**METROPOLITAN DEVELOPMENT COMMISSION  
REGIONAL CENTER HEARING EXAMINER**

**STAFF REPORTS FOR JANUARY 15, 2015**

<b>Case Number</b>	2014-REG-026
<b>Address (approx.)</b>	715, 720 and 723 East Maryland Street, 117 Concordia Street, and 116 and 125 South Davidson Street
<b>Location</b>	Center Township, Councilmanic District # 19
<b>Petitioner</b>	Herman Kittle Properties, Inc., by Joseph D. Calderon
<b>Zoning</b>	CBD-2 (RC)
<b>Request</b>	Regional Center Approval to provide for a multi-family residential development, consisting of approximately 211 dwelling units and a 152-space underground parking garage.

Site plan – 2014-REG-102

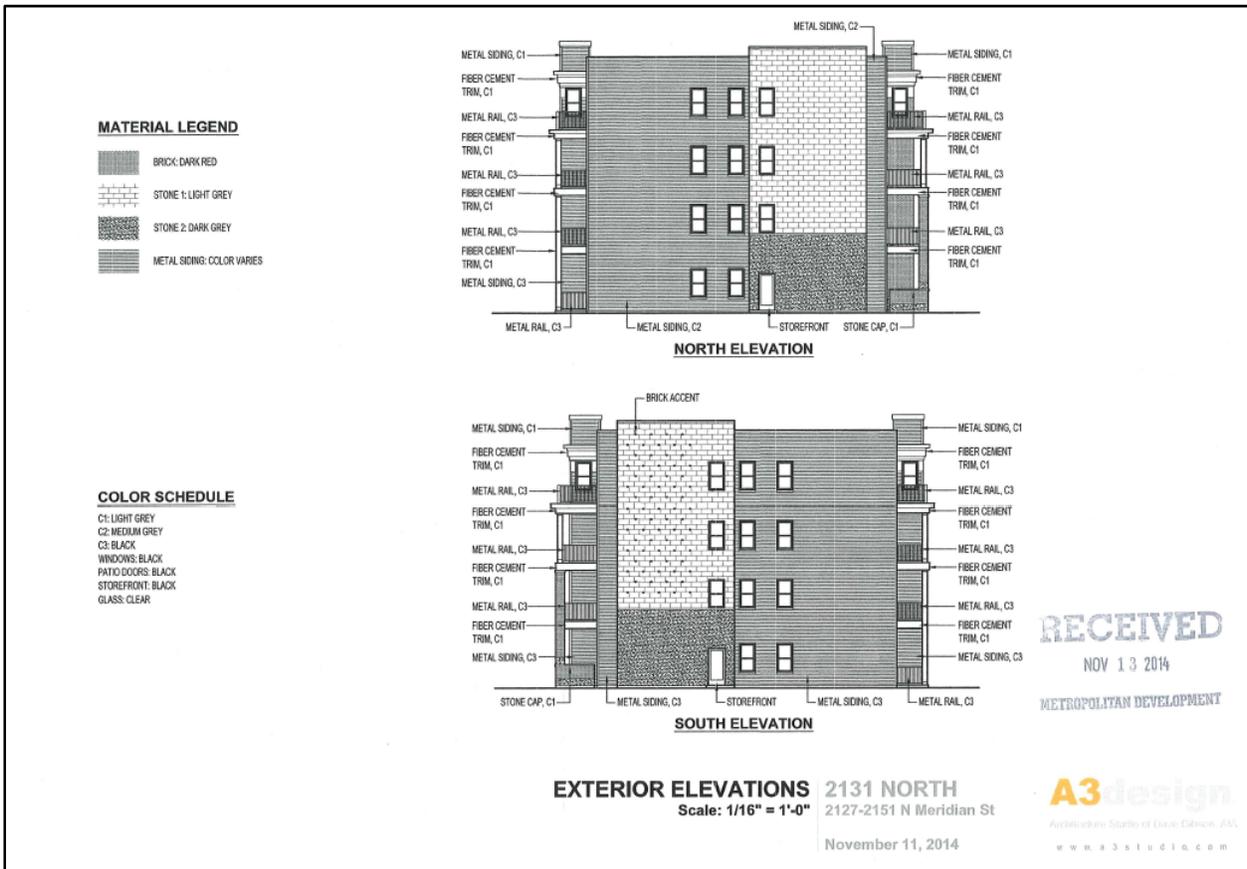
**2014-REG-012; 2127, 2131, 2133, 2137, 2139 and 2161 North Meridian Street (site)**, requests Regional Center Approval to provide for a multi-family residential development consisting of 46 dwelling units, **approved**.
